AIRBORNE EXPRESS

RE: Sequoyah Fuels Corporation
Preliminary Report
RCRA U3008(h) Administrative Order on Consent
U. S. EPA Docket No. VI-005-(h)93-H
EPA I. D. No. OKD051961183

SFC Response to EPA Comments

Preliminary Report: Current Conditions and Investigations

SFC SITE TERMS
FIGURE 1-1

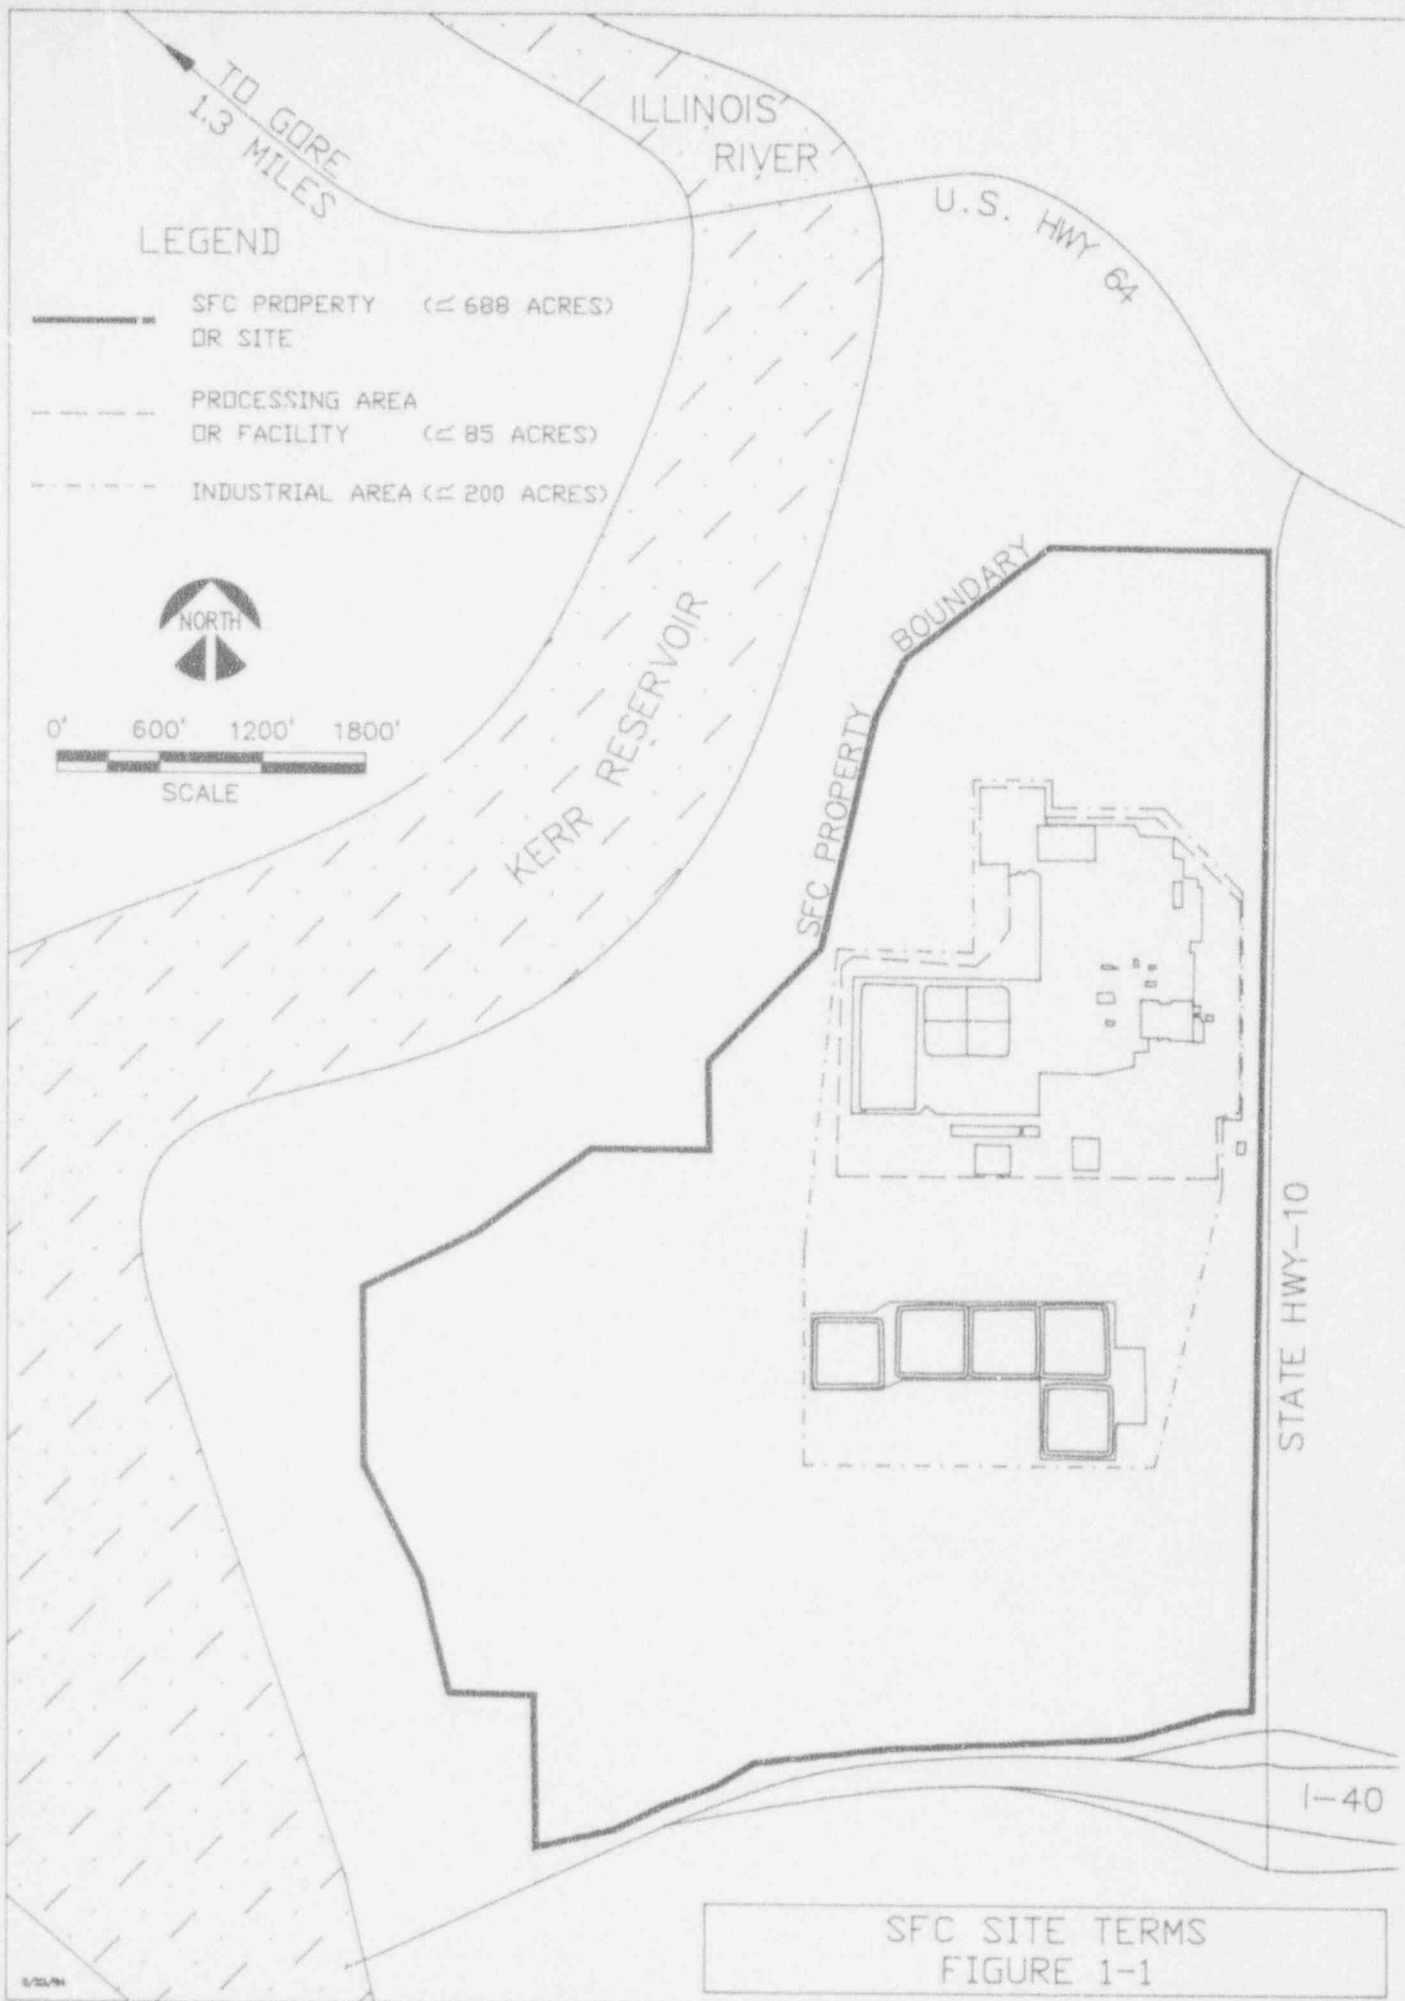
- The term "Site" has been used in this section but has not been previously defined. SFC shall indicate the definition of this term or shall delete it from the text.

Response: A new section, Section 1.6, and figure, Figure 1-1, have been added which define terms used in the report when referring to land owned by SFC.

LOCAL LAND USE
Figure 3-4

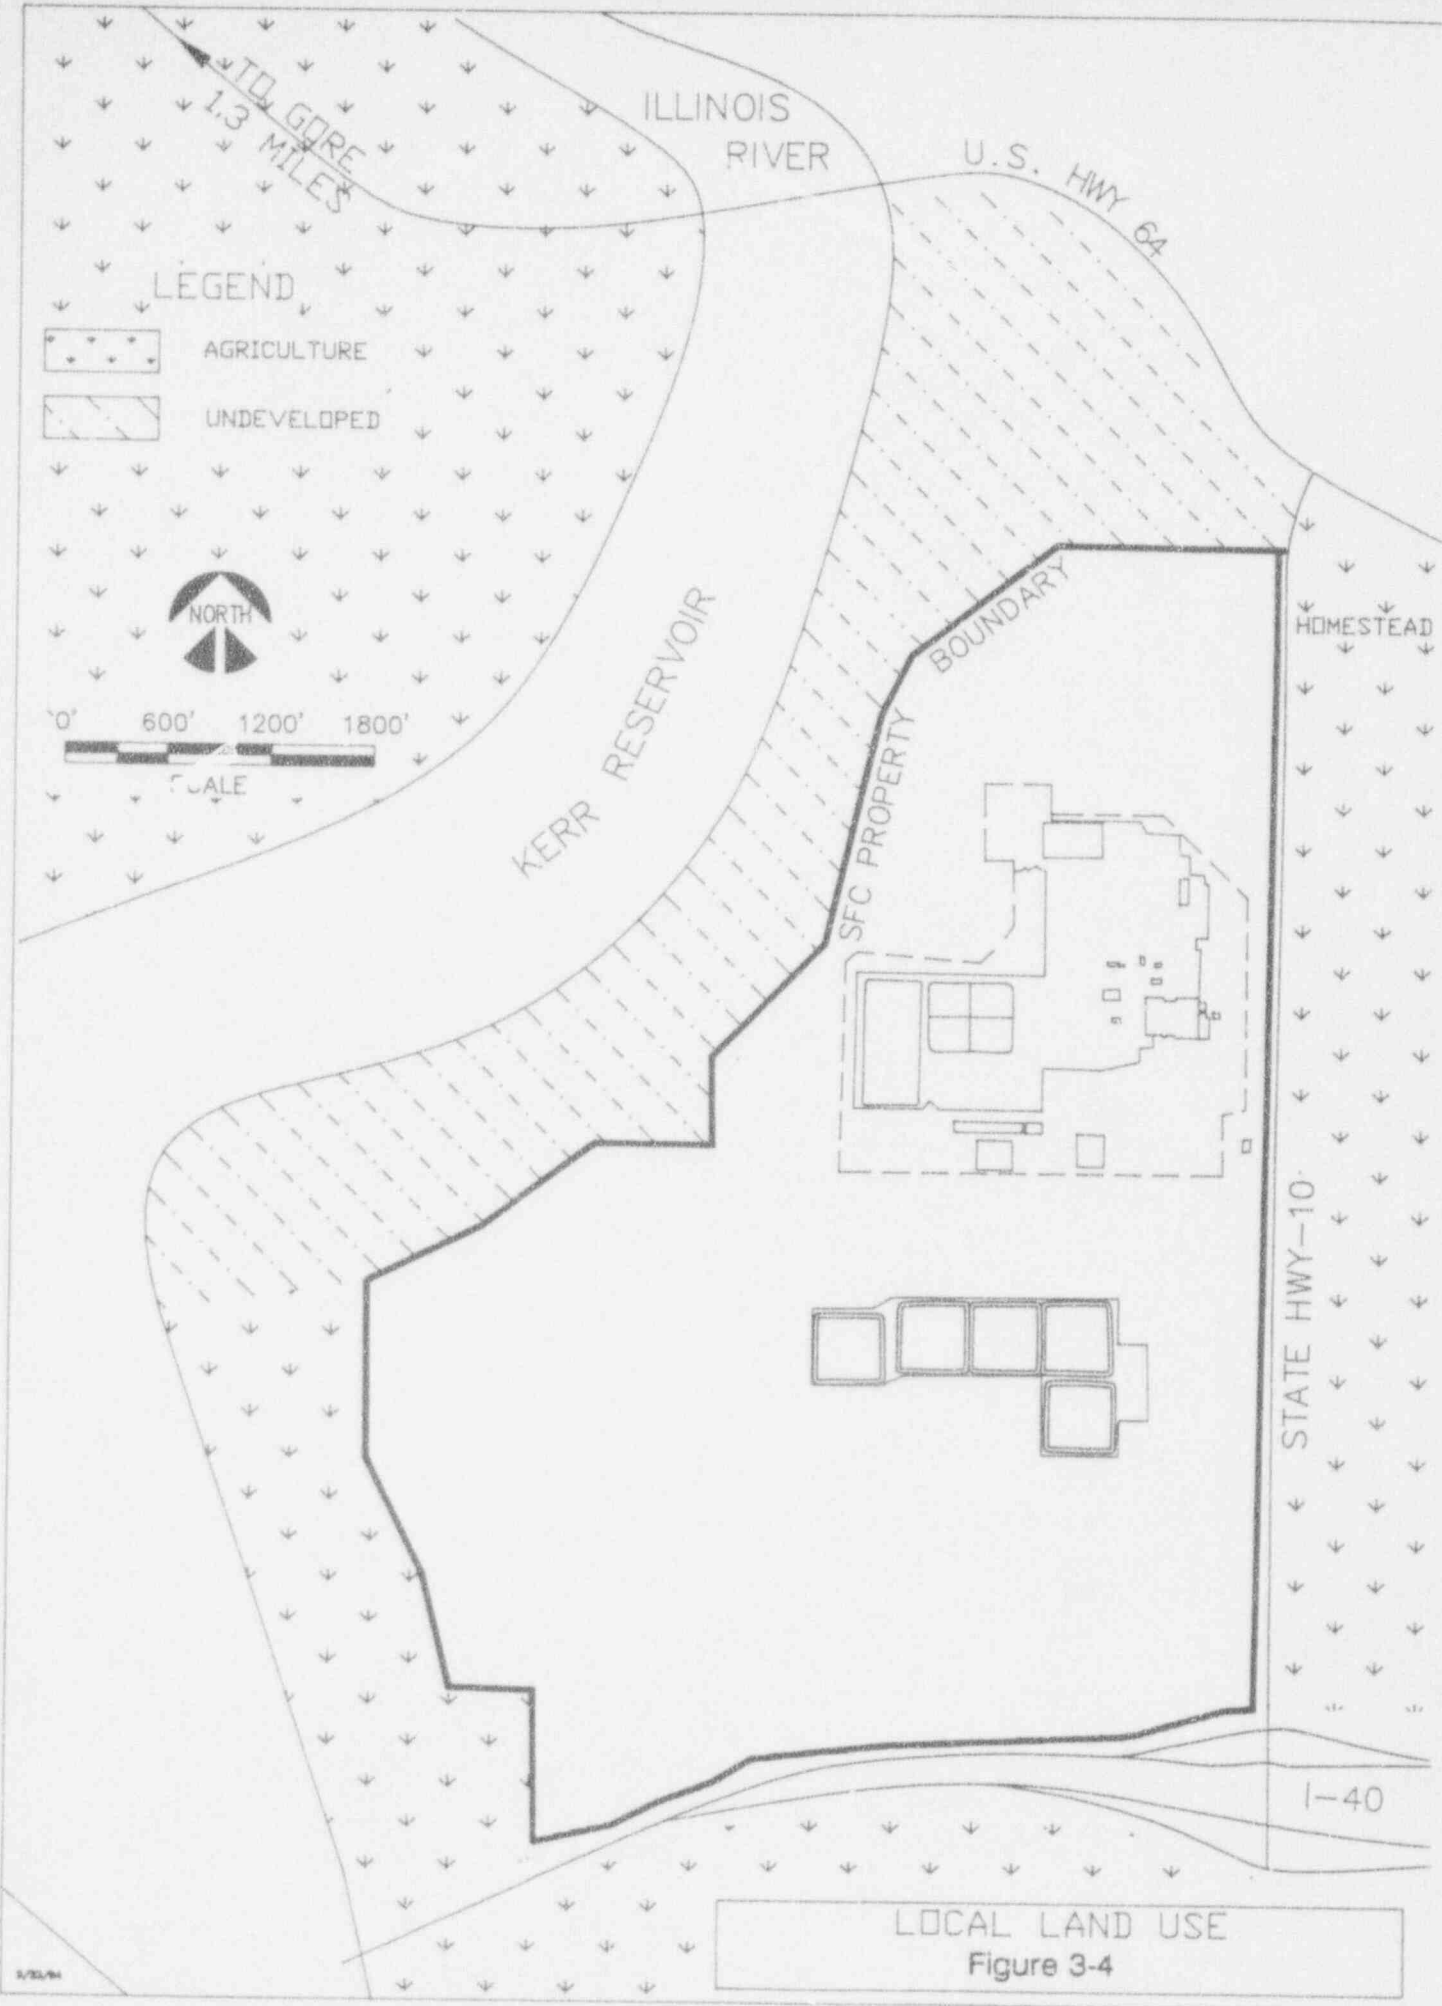
- Three subtasks (i.e. A.1.h, B.1.b, and B.1.d) do not reference any documents. As stated in the Appendix II, page 7, of the Order, SFC shall provide a written response or a reference to existing documentation which addresses the requested information. SFC shall provide the above information (i.e. response or reference) as it pertains to the three subtasks mentioned above.

Response: Subtask A.1.h requests a map showing land use surrounding the site. Since no such map existed at the writing of the Preliminary Report SFC provided a narrative

description of land use in a 10-mile radius surrounding the site in Section 3.6.2. The section does contain a table (Table 3-9) which summarizes local land use. In response to EPA's comment a map showing land use immediately surrounding the site has been produced and is designated as Figure 3-8 in the CCI. Table B-1 has been changed to reflect the inclusion of this table within the CCI.
